STAFF REPORT
COMMUNITY DEVELOPMENT DEPARTMENT

HEARING DATE: 10/21/2025
TO: Mayor & City Council
FROM: Sonya Allen, Associate Planner
208-884-5533
SUBJECT: Brundage Estates Subdivision No. 2
FP-2025-0023
LOCATION: Generally located on the east side of S. Linder Rd., 1/2 mile south of W. Victory Rd., in the west 1/2 of Section 25, T.3N., R.1W.

Final plat consisting of 36 buildable lots and 11 common lots on 12.57 acres of land in the R-4 zoning district for the second phase of Brundage Estates Subdivision.

A. Preliminary Plat (dated: 01/06/16)

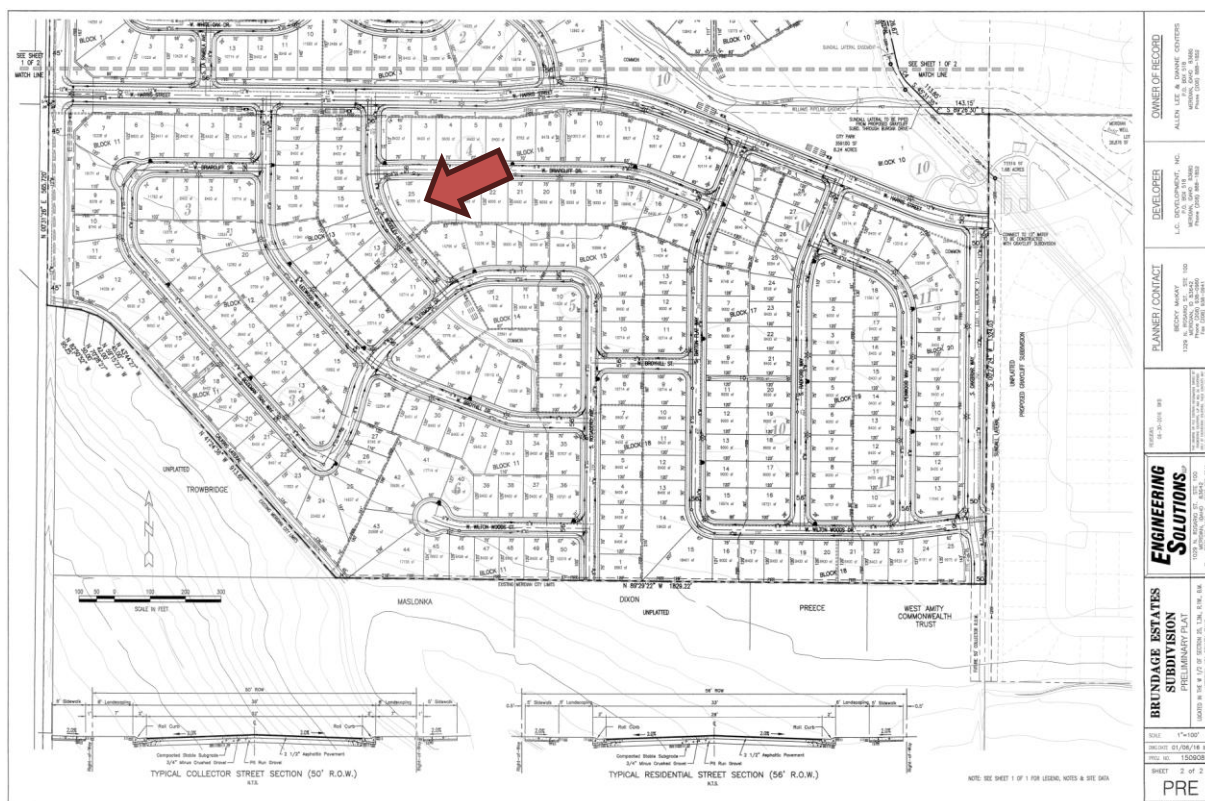
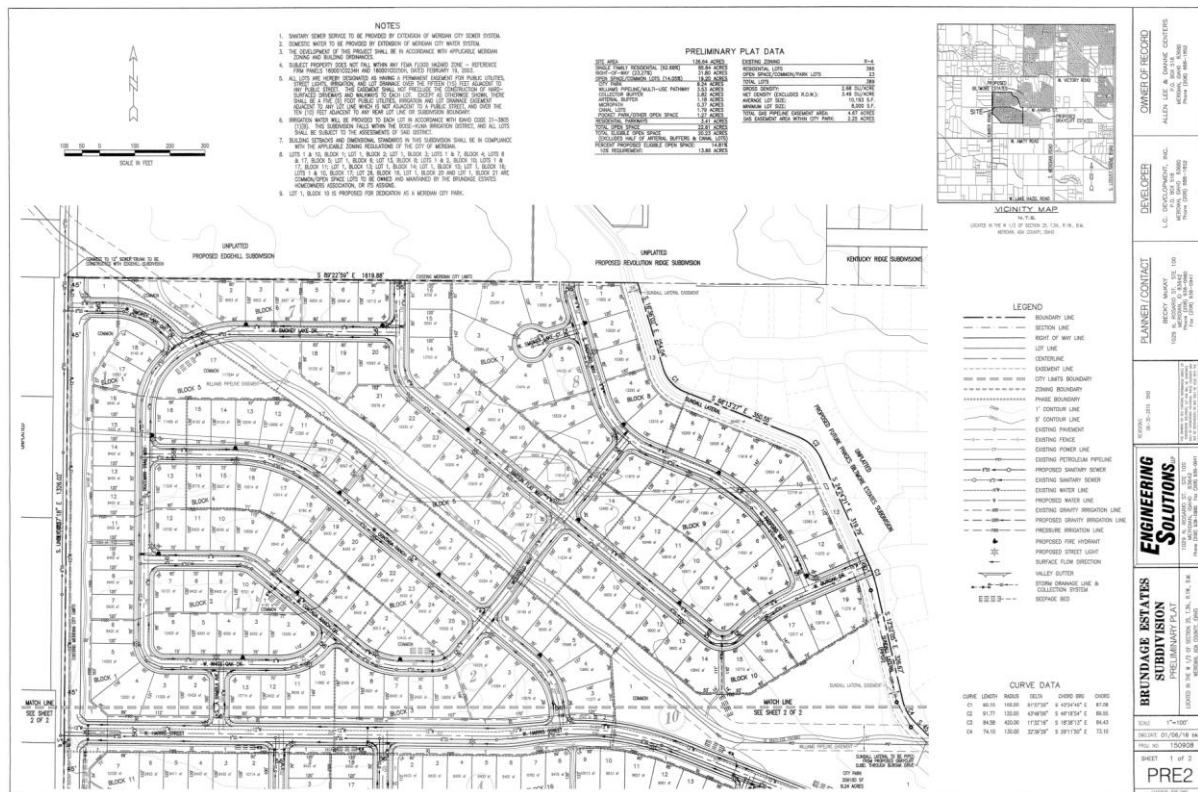
The street layout shown on the approved preliminary plat had to be reconfigured to meet the current ACHD Policy Manual requirement that local street intersections with a collector roadway be offset 330' from centerline. This change resulted in two (2) fewer buildable lots in Phase 1 and one (1)

additional building lot in Phase 2 for a total of one (1) less buildable lot overall; and 1.2 acres more qualified open space in Phase 1 and 1.32 acres more qualified open space in Phase 2 for a total of 2.52 acres more than shown on the approved preliminary plat.

Because the number of buildable lots has not increased and the amount of common open space has not decreased, Staff deems the proposed final plat to be in substantial compliance with the approved preliminary plat as required.

LANDSCAPE PLAN

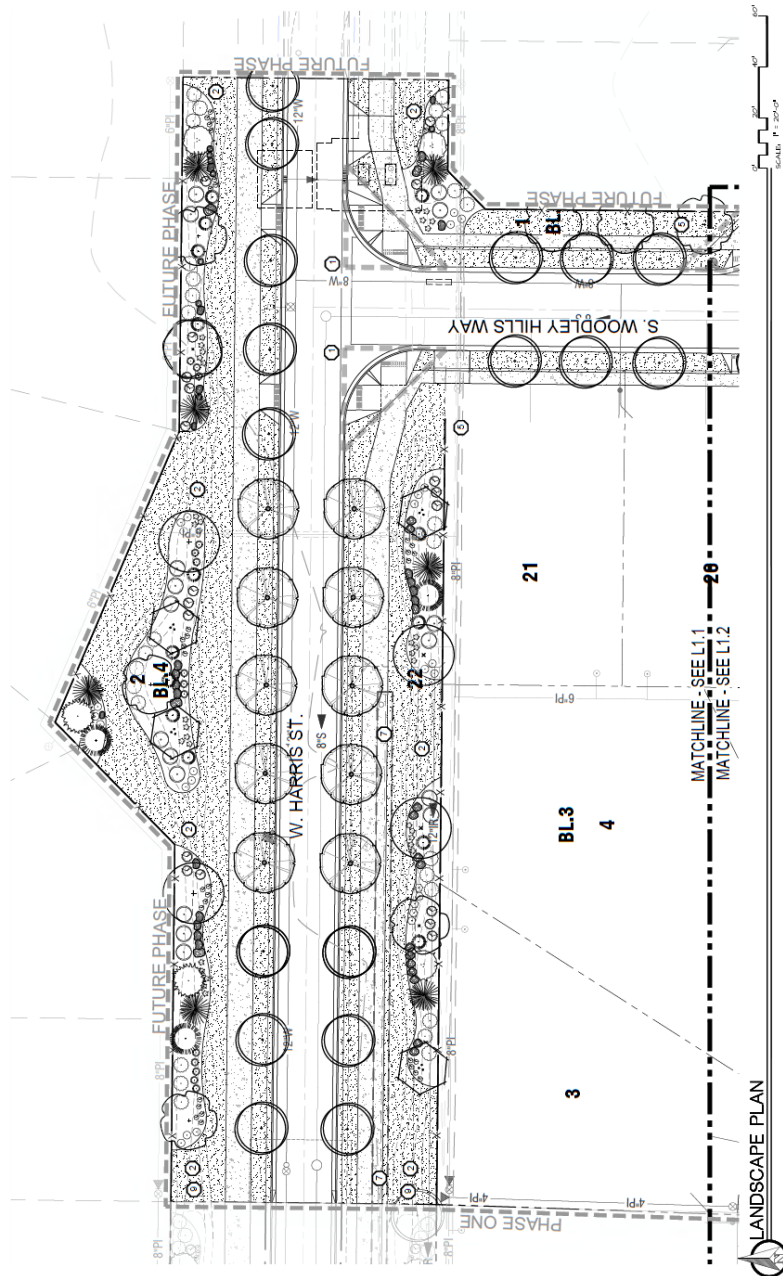
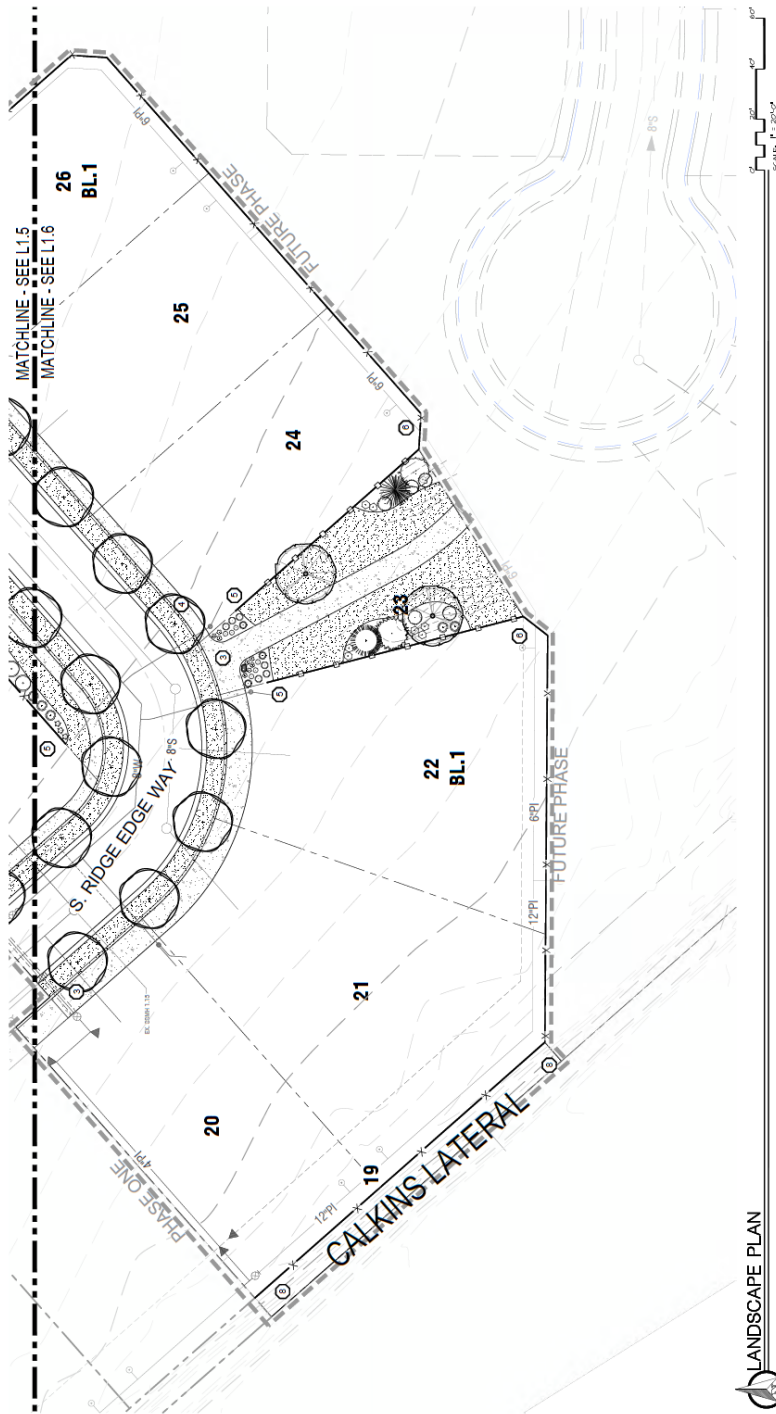
A revised plat shall be submitted with the final plat signature application.
5. The landscape plan shown in Section V.C, dated 8/7/2025, shall be revised as follows:
 - a. Include additional landscaping along the pathway on Lot 20, Block 2 and Lot 10, Block 3 in accord with the standards listed in UDC 11-3B-12C.
 - b. The fencing type along the rear lot lines of Lots 20 and 21, Block 1 adjacent to the common lot (i.e. Lot 19, Block 1) where the Calkins Lateral has been piped shall be changed to an open vision or semiprivate fence up to six (6) feet in height or four (4) feet in height if closed vision fencing is used [an additional two (2) feet in height of open vision fencing may be provided to the top section of the fence], per UDC 11-3A-7A.7b.

A revised landscape plan shall be submitted with the final plat signature application.
6. Prior to the issuance of any new building permit, the property shall be subdivided in accordance with the UDC.
7. All fencing shall comply with the standards of UDC 11-3A-7C.
8. All development shall comply with the dimensional standards for the R-4 zoning district listed in UDC *Table 11-2A-6*.
9. All homes constructed shall be generally consistent with the conceptual elevations included with the development agreement (Inst. #[2024-070384](#)).
10. The rear and/or sides of homes facing W. Harris St. (Lots 3, 4 and 21, Block 3) shall incorporate articulation through changes in two or more of the following: modulation (e.g. projections, recesses, step-backs, pop-outs), bays, banding, porches, balconies, material types, or other
